Project Title: Redlands Passenger Rail Project (RPRP)

## Addendum No. 6 to the EIR

San Bernardino County Transportation Authority |  
Redlands Passenger Rail Project

March 2018

Figure 3. Downtown Redlands Station Platform – Design Progression from 90 to 100 Percent Design

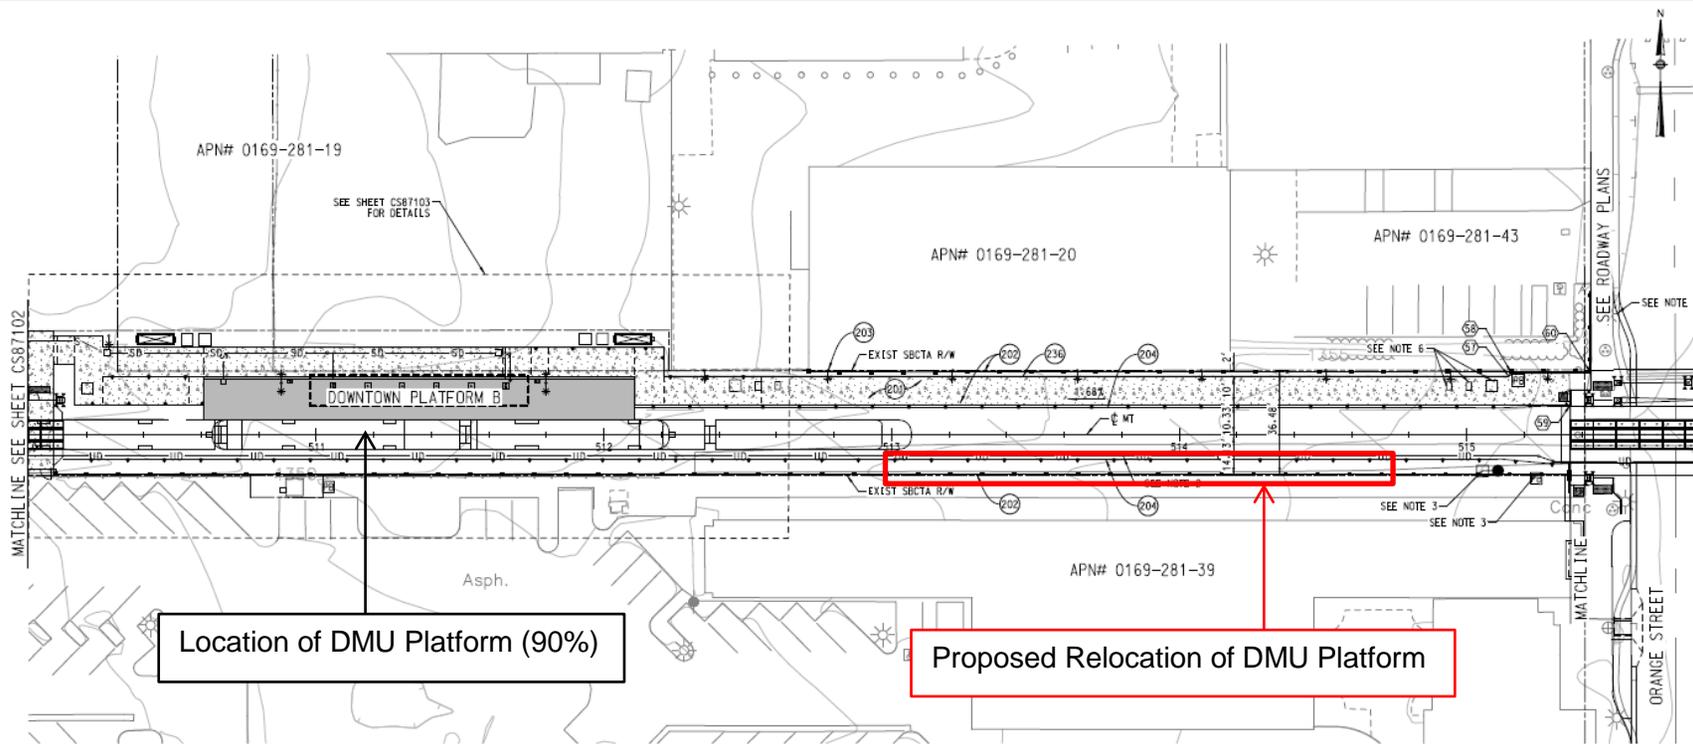
**Refinement 1 – Downtown Station DMU Platform Relocation:** The approved Project and 90 percent engineering plans reflect a platform configuration at the Downtown Redlands Station that places the boarding platforms north of the track centerline and west of Third Street and the Redlands Santa Fe Depot (Attachment A, Figure 3). As considered in the Final EIR, SBCTA proposed to construct a single boarding platform that would serve both the DMU and Metrolink express services. Following additional design, SBCTA split the platform into two separate Metrolink and DMU platforms, as reflected in the 90 percent design for the Downtown Redlands station.

In the fall of 2017, the Depot's ownership changed. Following discussions with the City of Redlands, the new owner approached SBCTA regarding relocating the DMU platform to a location south of the track centerline, and directly north of the Depot. Following additional coordination with City of Redlands, Omnitrans, and Metrolink, SBCTA is proposing to relocate the DMU platform as part of the Project's 100 percent design. The relocated platform would have a maximum width of 16 feet and a length of 170 feet, similar to the 90 percent design. Attachment A, Figure 5 illustrates the preliminary DMU platform design concept. As shown, the platform would largely be contained within SBCTA's right-of-way. A small easement would extend into the northern perimeter of the Depot property (as steps) and into the existing lawn area<sup>2</sup>. The platform would extend approximately two feet above the existing grade with pedestrian access and Americans with Disabilities Act (ADA) accessible ramps (with railings) extending off the east and west ends of the platform. A series of wide-stair steps (with railings) may also be integrated to provide enhanced access from the platform to the grand plaza (south). No canopy structure(s) are proposed. Platform lighting would be included as depicted in Attachment A, Figure 5.

Location of DMU Platform (90%)

Proposed Relocation of DMU Platform

Figure 5. Proposed Downtown Redlands Station Platform Relocation (100 Percent Design)

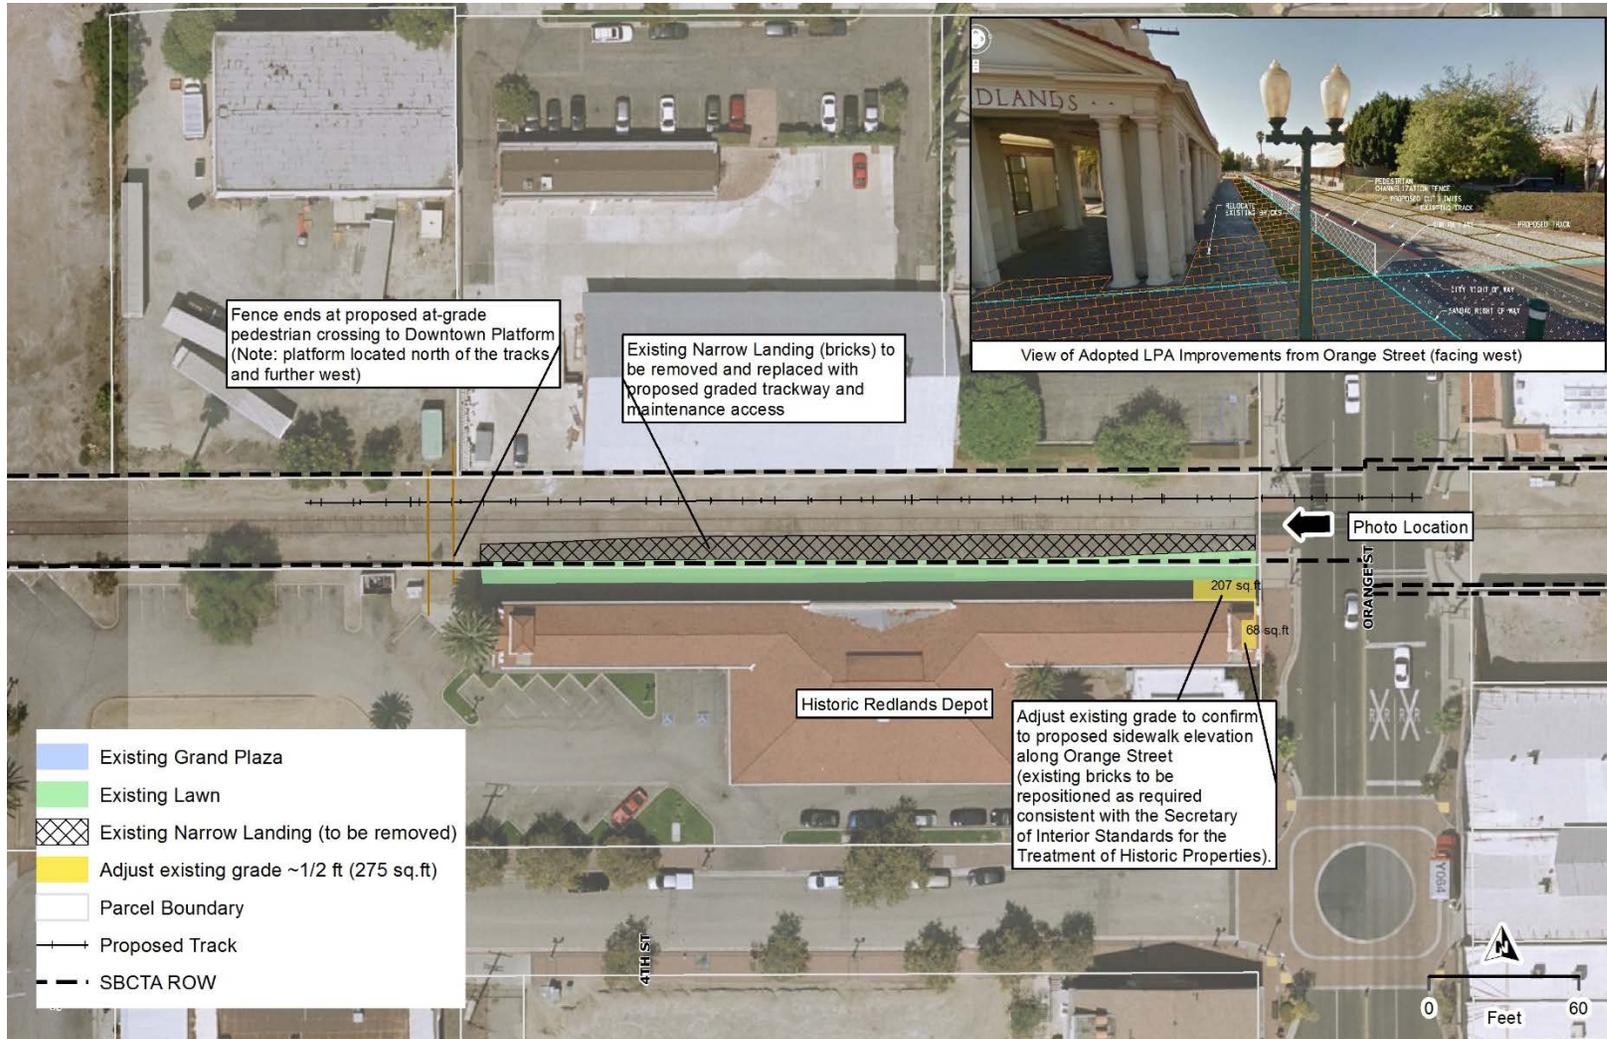
As a part of Refinement 1, the pedestrian at-grade crossing and Metrolink platform, as reflected in the 90 percent design, would be maintained in their current positions as reflected in the 100 percent engineering design (Attachment A, Figure 5).

Figure 7. Proposed DMU Platform at Downtown Redlands Station

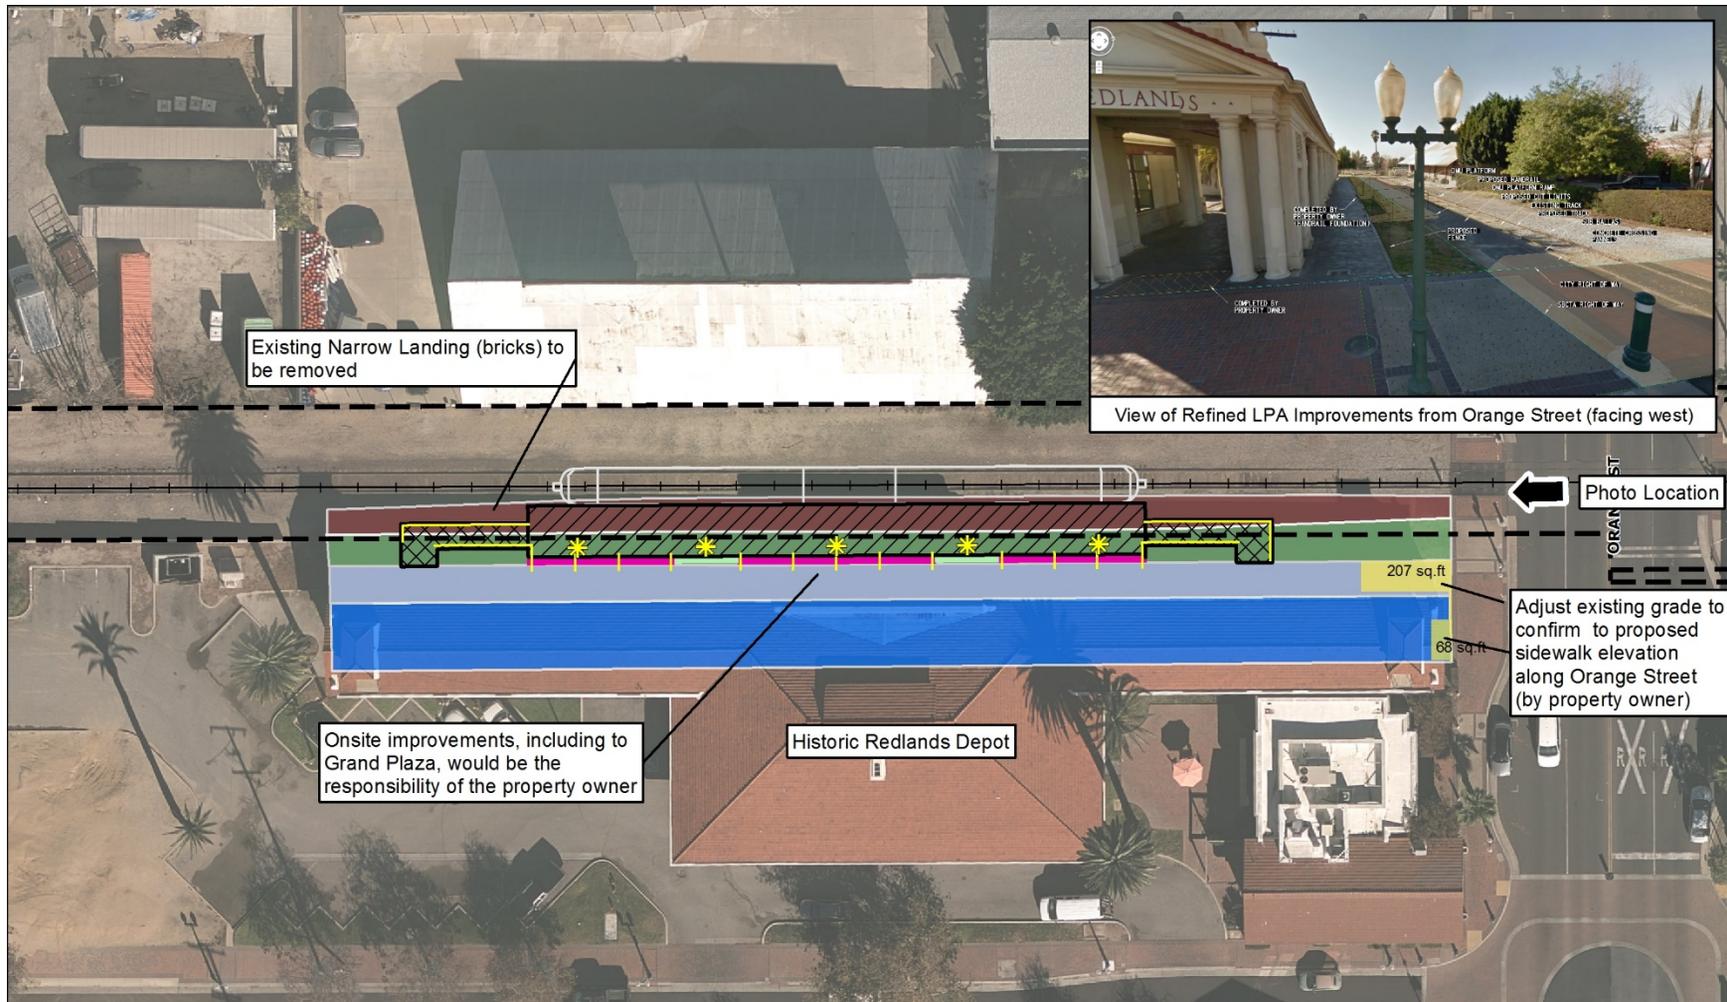
The stairs located on the south edge of the DMU platform would be inset into the platform so as to avoid any direct impacts to the grand plaza or other adjacent historic fabric. Concrete planters planned to be located within the staircase will also not impact historic fabric and will be minimally obtrusive. Both the ramps associated with the platform and their railings will be included entirely within the narrow grass strip. Lighting associated with the platform will be located directly on the platform and will match those located immediately adjacent to the Depot along Orange Street, as well as those located on the Depot property adjacent to the parking lot. There will be no canopy associated with this platform.

Figure 1. Downtown Redlands Station Platform – Design Progression from 2015 EIR to March 2018

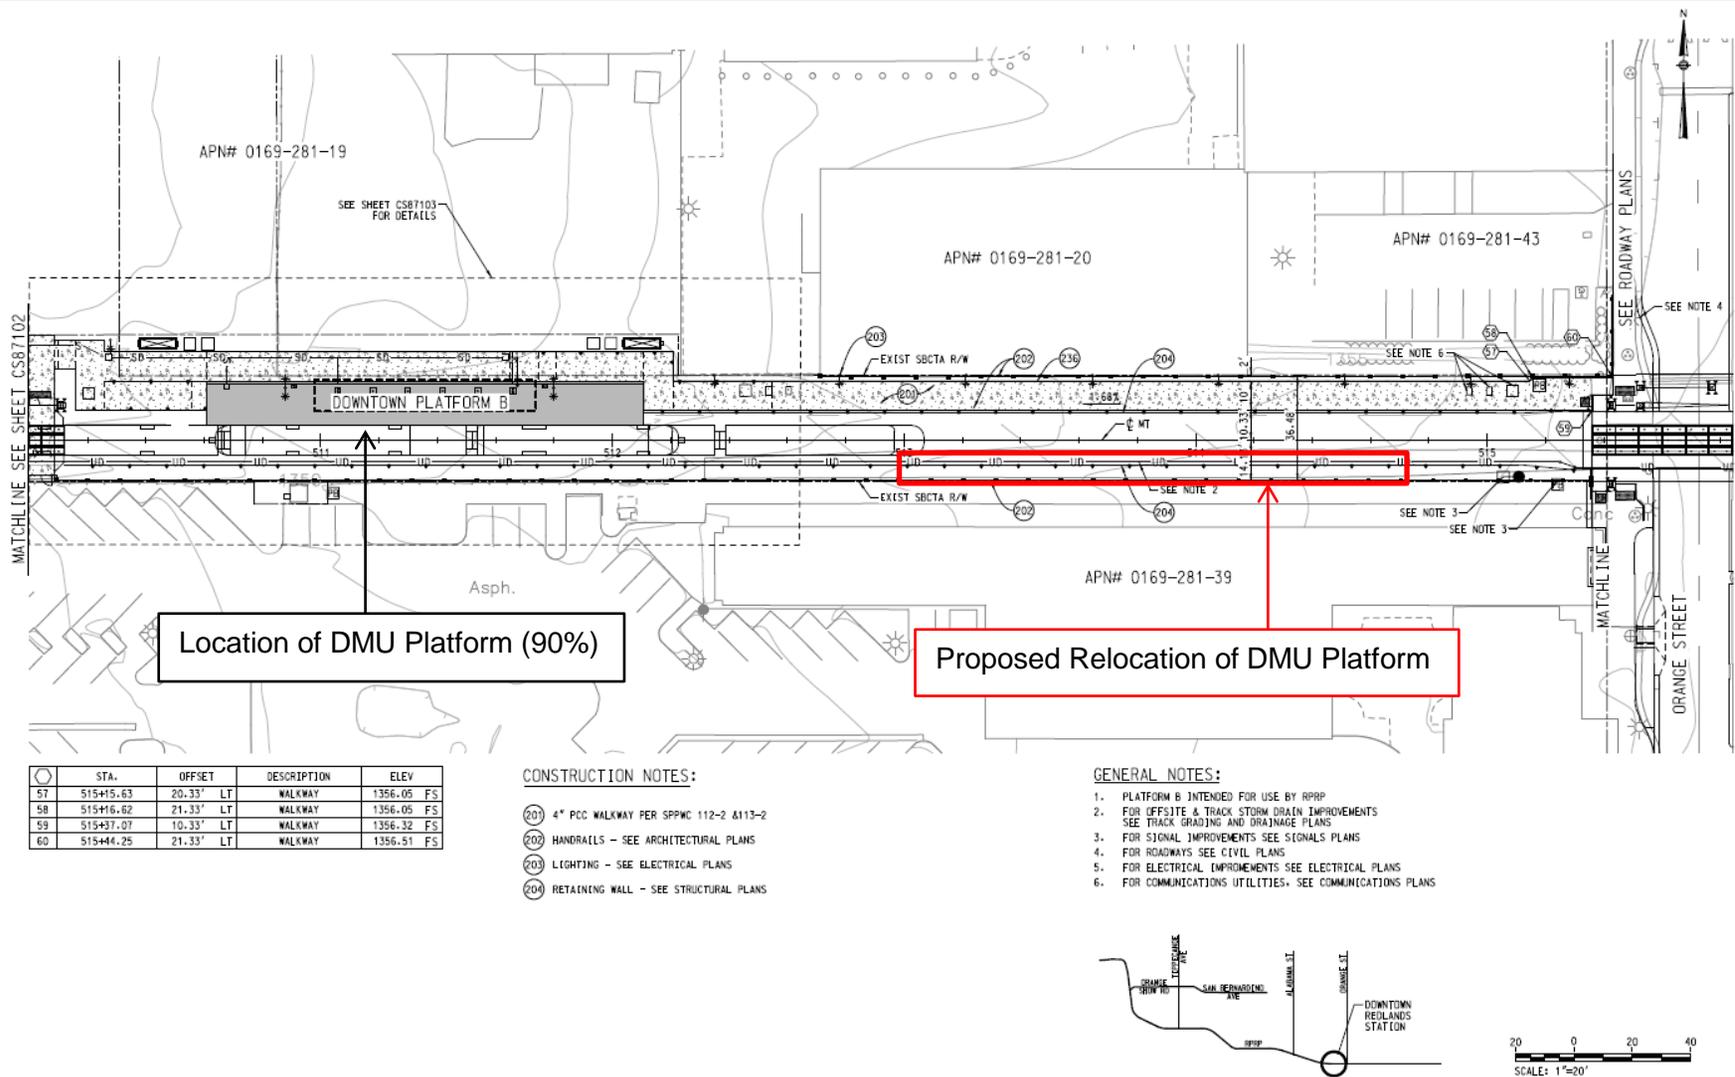
**Refinement No. 1 – Downtown Station DMU Platform Relocation:** The approved Project and 90 percent engineering plans reflect a platform configuration at the Downtown Redlands Station that places the boarding platforms north of the track centerline and west of Third Street and the Redlands Santa Fe Depot (see Figure 1). As considered in the Final EIR, SBCTA proposed to place a single boarding platform that would serve both the DMU and Metrolink express service. Following additional design refinements, SBCTA split the platform into two separate Metrolink and DMU platforms as reflected in the 90 percent design for the downtown Redlands station.

Figure 3. Proposed Downtown Redlands Station Platform Relocation (100 Percent Design, March 2018)

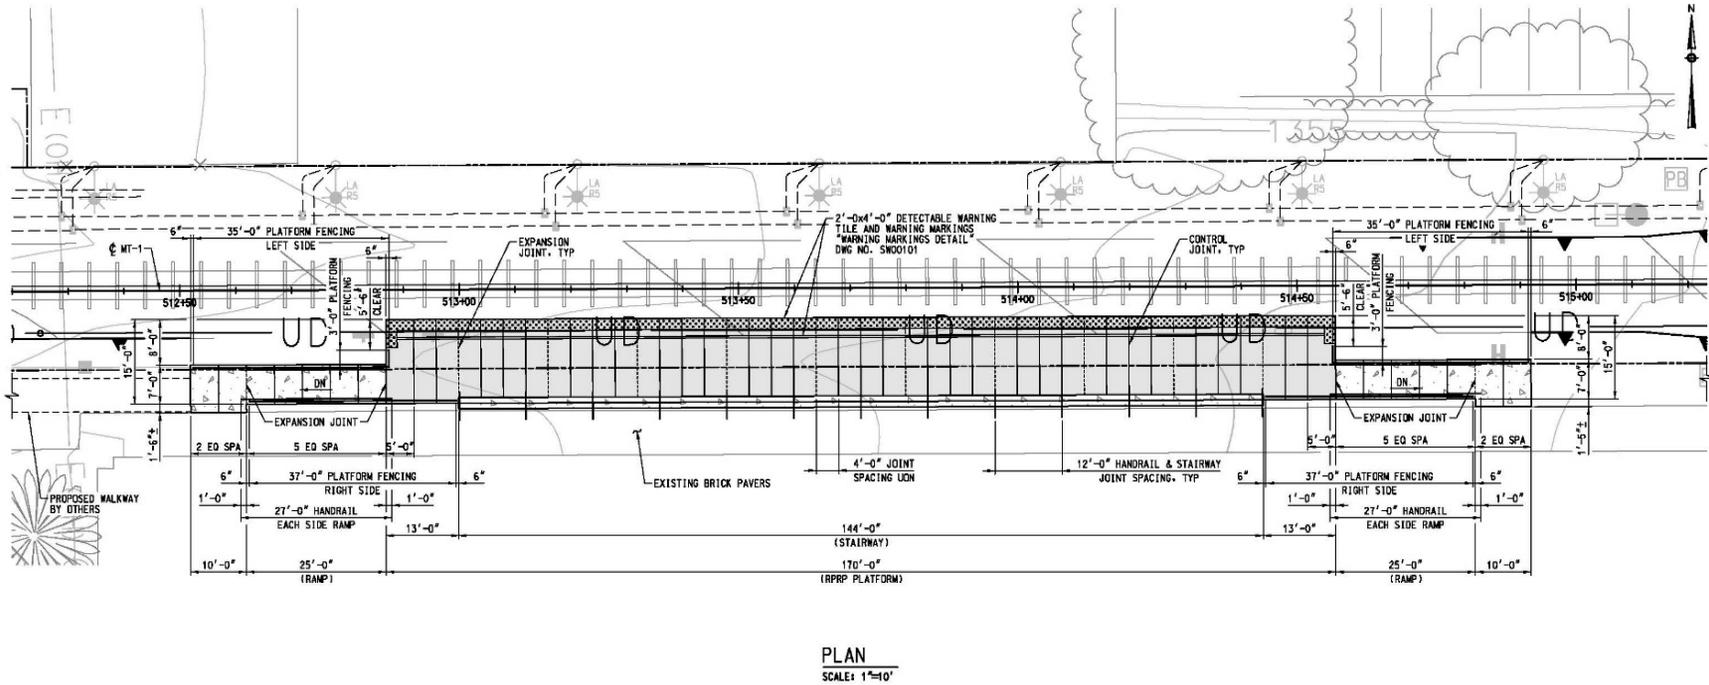
approximately two feet above the existing grade with pedestrian access and Americans with Disabilities Act (ADA) accessible ramps (with necessary railings) extending off the east and west ends of the platform allowing for transition onto the grand plaza without altering the plaza in any way. The railings associated with the ramps will be minimally obtrusive within the setting of the Depot and will not attach to the historic bricks within the grand plaza. A series of wide-stair steps will also be integrated to provide enhanced pedestrian access from the platform to the grand plaza (immediately south). No canopy structure(s) are proposed at this location. Lighting proposed will be the same as those currently present on the sidewalk adjacent to the depot on Orange Street and within the Depot property adjacent to the parking lot. These lights are replicas of 1913 lights that once lined the streets of Redlands (see Figures 5 and 6). Thus, the lighting will be compatible with the current setting of the Depot. Railings proposed for accessing the staircase inset into the platform will be the responsibility of the property owner. The property owner is still finalizing the design of these proposed handrails, and has been advised that they should be minimally obtrusive within the landscape and should minimally impact remaining historic fabric adjacent to the platform.

Revised Area of Potential  
Effects (APE)

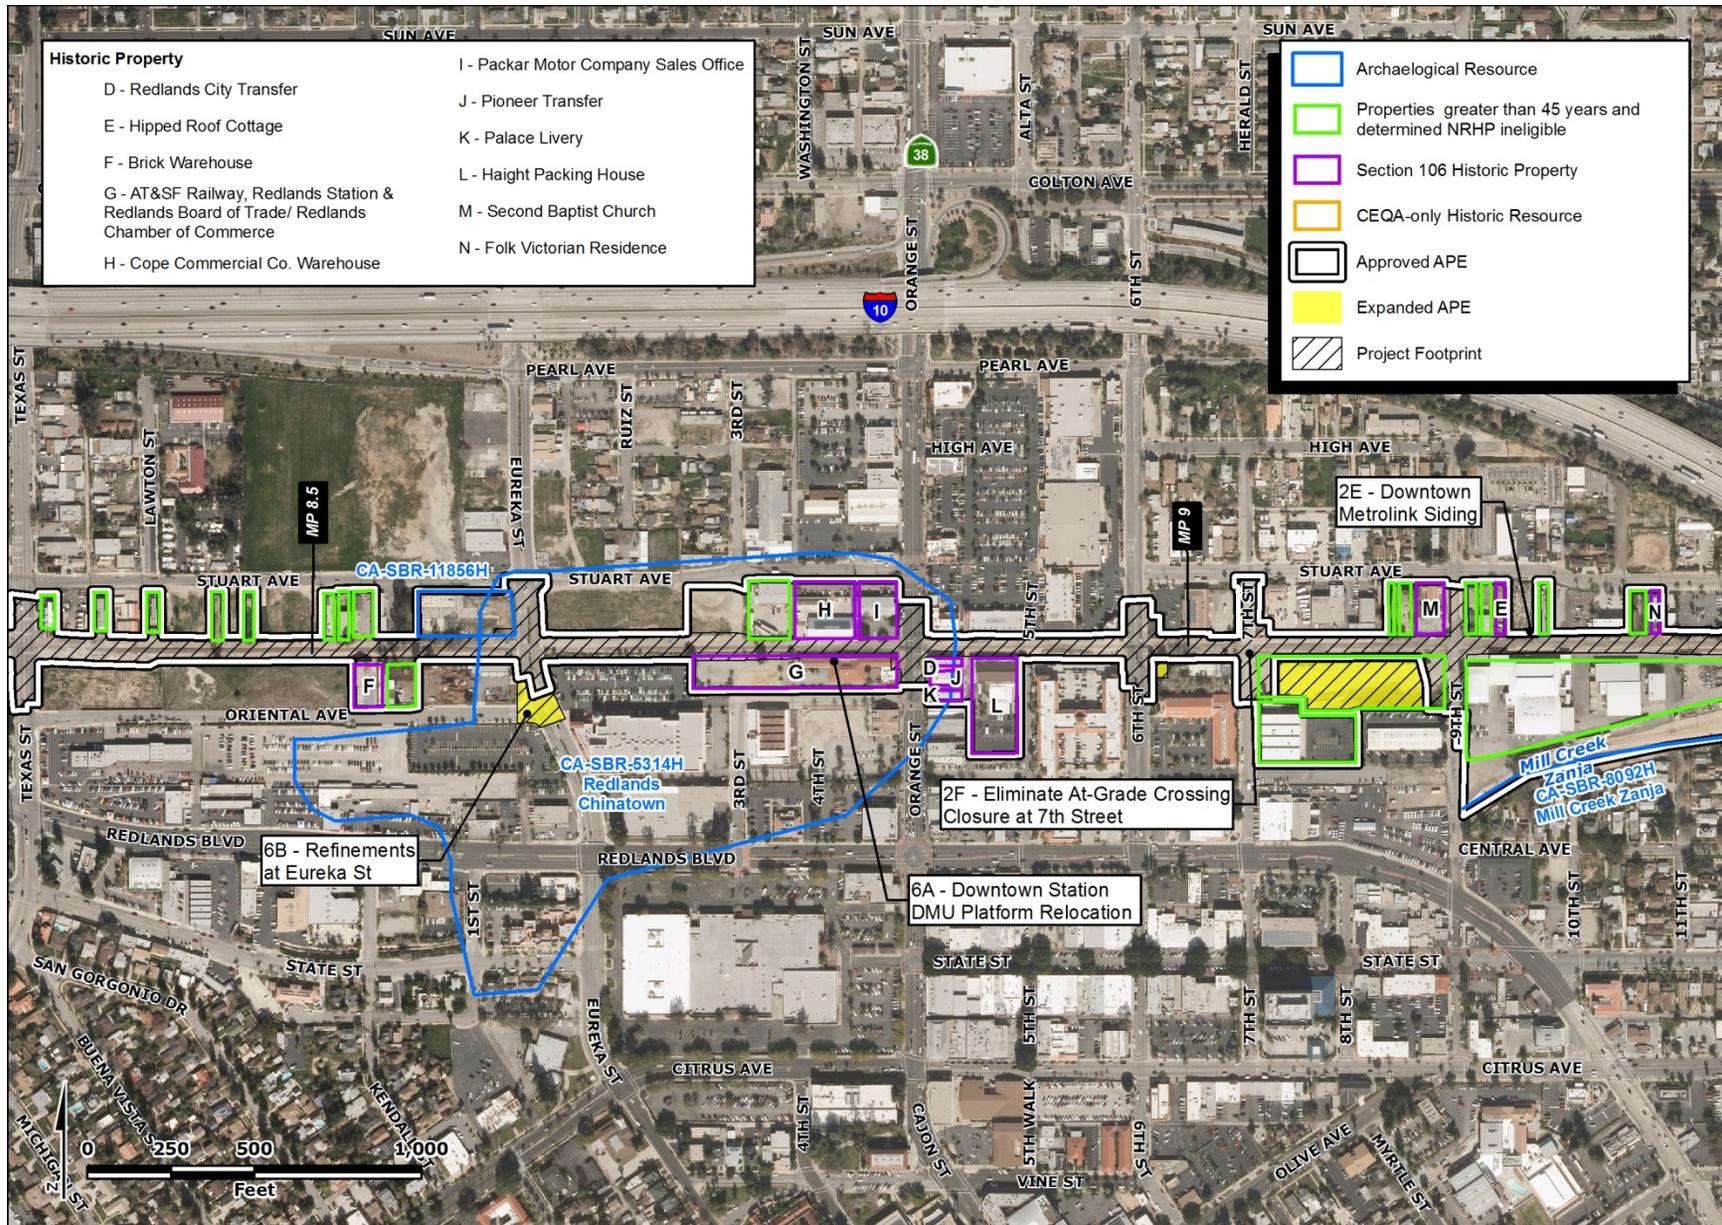
The original project APE was compared to the minor design refinements and the adopted EIR, and a revised and expanded APE was developed to address the refinements (see **Appendix A**). The revised APE encompasses the original 2015 APE and was expanded in one small area totaling approximately 0.3 acres to accommodate minor design refinements related to Refinement 2 (see Figure 7). This includes a minor APE expansion within the area south of Eureka Street for use in construction activities and the relocation of a signal house to the southwest quadrant of the intersection of the rail line and Eureka Street. The minor APE expansion that would occur due to Refinement 2 would be entirely located within the roadway right-of-way and would not extend into any adjacent parcels.
